## **Urgent Field Safety Notice** **Column iC**

<b>1. Information on Affected Devices*</b>	
1	1. Device Type(s)*
.	Floor Mounted Tubestand
1	2. Commercial name(s)
.	Column iC
1	3. Unique Device Identifier(s) (UDI-DI)
.	N/A
1	4. Primary clinical purpose of device(s)*
.	The medical purpose of Column iC is diagnostic radiology
1	5. Device Model/Catalogue/part number(s)*
.	see attachment 3
1	6. Software version
.	not relevant
1	7. Affected serial or lot number range
.	see attachment 3
1	8. Associated devices
.	N/A

### **Service Note NIM04-2021**

*Subject:* Pin soldering verification

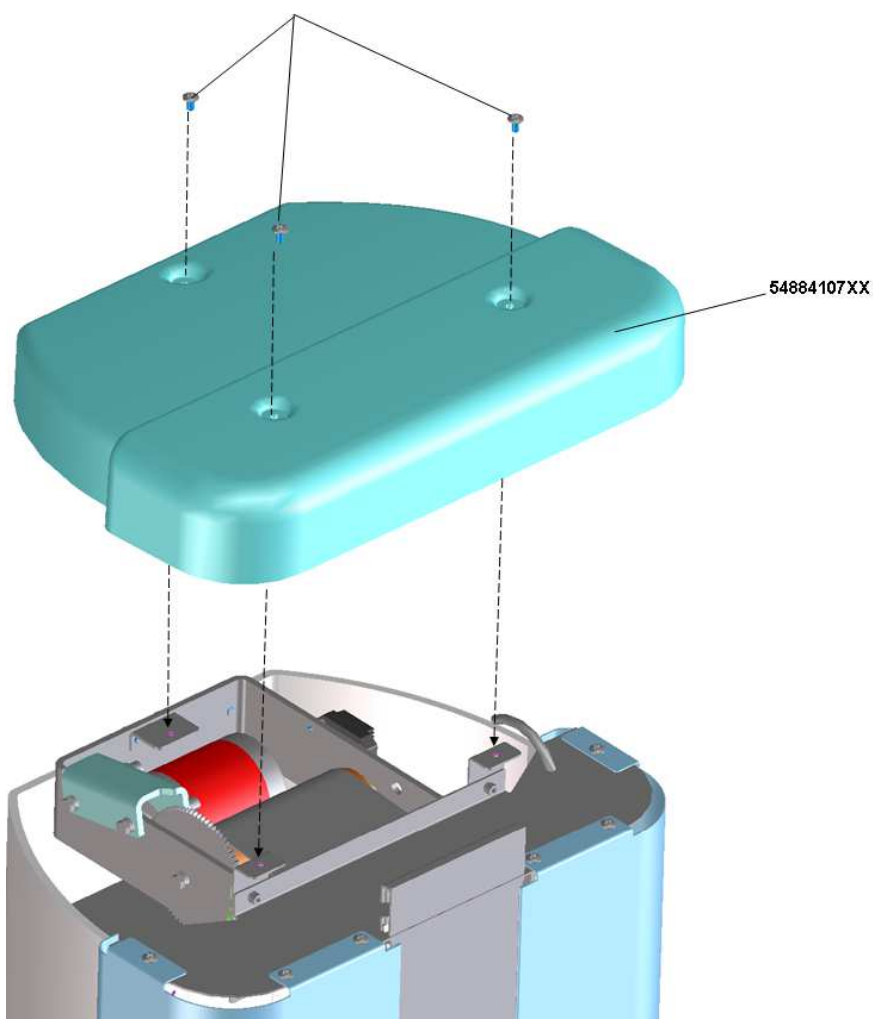
Just for reference, here following the type of verification to be done in field on installed units, where it is visible, without dismounting x-ray tube, the difference between correct welding, that should have the weld throat size of about 4mm, and non compliant welding

In green you can see the correct weld throat size

For better understanding, here following the differences between a correct welding (green arrow) and a non compliant welding (red arrow).

In case you find this type of welding, it is required the tube support replacement.

In case it is necessary the replacement, the spare part code is:

- code 5288701200 pin for Column iC:
